Property File Information

Property Address: 47 AQUARIUS DRIVE
KAWAHA POINT
ROTORUA

SUBDIVISION - PT KAWAHA 3FL BLOCK, BLOCK XVI ROTORUA S.D. AND BLOCK
XIII ROTOITI S.D. AQUARIUS DRIVE - CARTER HOLT HARVEY
LTD

FOUNDATION TEST SITES
 AQUARIUS DRIVE ROTORUA

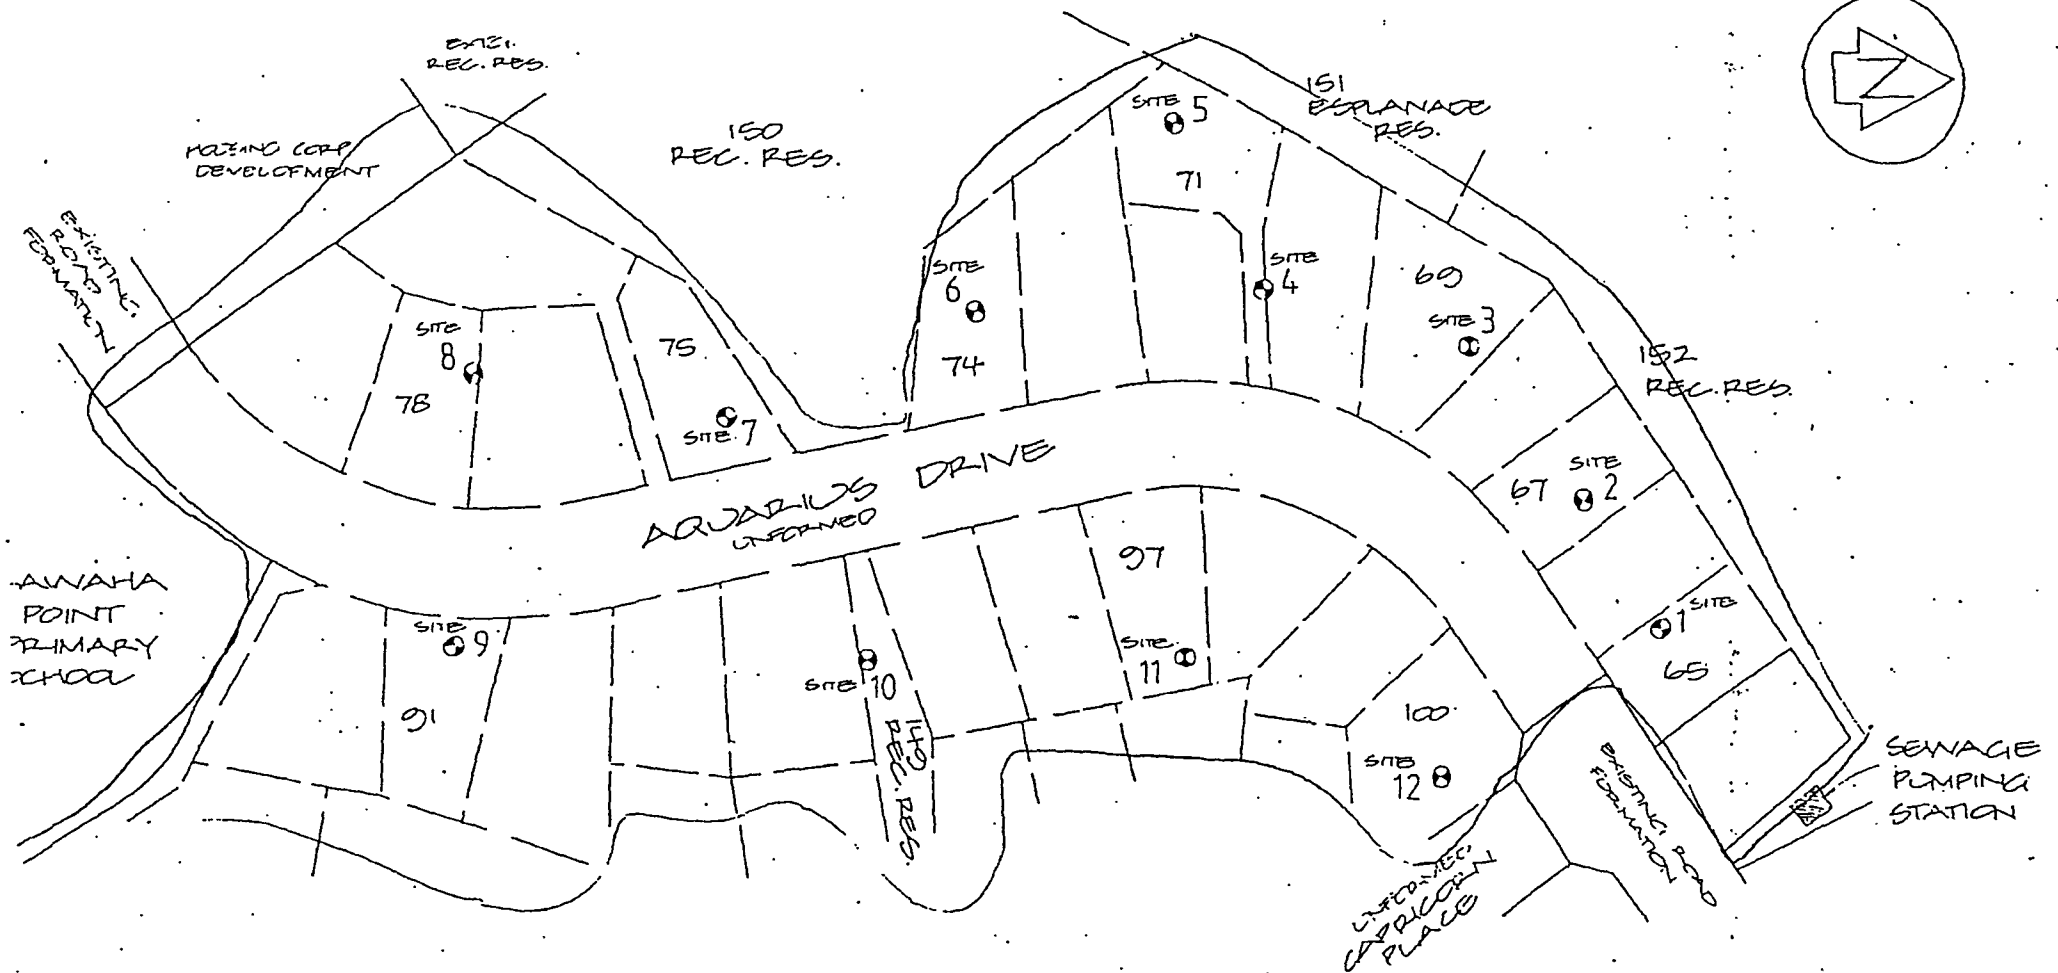
Testing was restricted to within the area outlined on your plan included with your instruction to proceed. Our plan 32263/10, Sheet 1, indicates each of the 12 test sites within that envelop.

Tests 1 - 6 indicated various depths of fill (.8m at No 6 and approximately 1.0m at No's 1 - 5).

The fill layer was hard, well compacted, pumice loam in holes 1 - 4 with less compacted and darker coloured loam (i.e. some brown earth contamination) in holes 5 and 6.

The water table for holes 1 - 6 was at about 2.0m below ground level.

Tests 7 - 12 were in natural ground with no indication of fill. However, the levels of different strata (e.g. fine sand or pumice layers) indicated that these areas had been subject to cut (i.e. material had been borrowed from these areas; probably for the fill on the other side of Aquarius Drive).

Generally the material in holes 7 - 12 was fine pumice sands, coarse pumice and moist silt. The latter occurred in holes 8, 9, 10 and generally at a depth of 1.5m or more below ground level.

The water table for holes 7 - 12 varied between 1.7m (hole 12) below ground level to not located (holes 8, 9).

Tests in the compact fill layer (sites 1 - 4) indicated ground bearing strength (g.b.s.) values of 150KPa or greater. The g.b.s. values for underlying layers (including the topsoil at original ground level) were generally around 200KPa.

Tests at sites 5 and 6 were reasonably similar to No's 1 - 4 but had g.b.s. values less than 100KPa within the top 1.0m for No 5 and 0.5m for No 6.

Of the remainder (No 7 - 12) site 10 had the worst g.b.s. values (around 150 KPa for the top 1.0m and then around 70 KPa below 1.0m i.e. in a fine wet sand and silty sediment layers).

Other sites tested at 160KPa or better to the end of each test (at 1.6m).

In our opinion the bores and g.b.s. tests indicated the area tested is suitable for normal residential development (compatible with NZS 3604 and NZS 4203) with standard foundation construction in accordance with normal acceptable engineering practice.
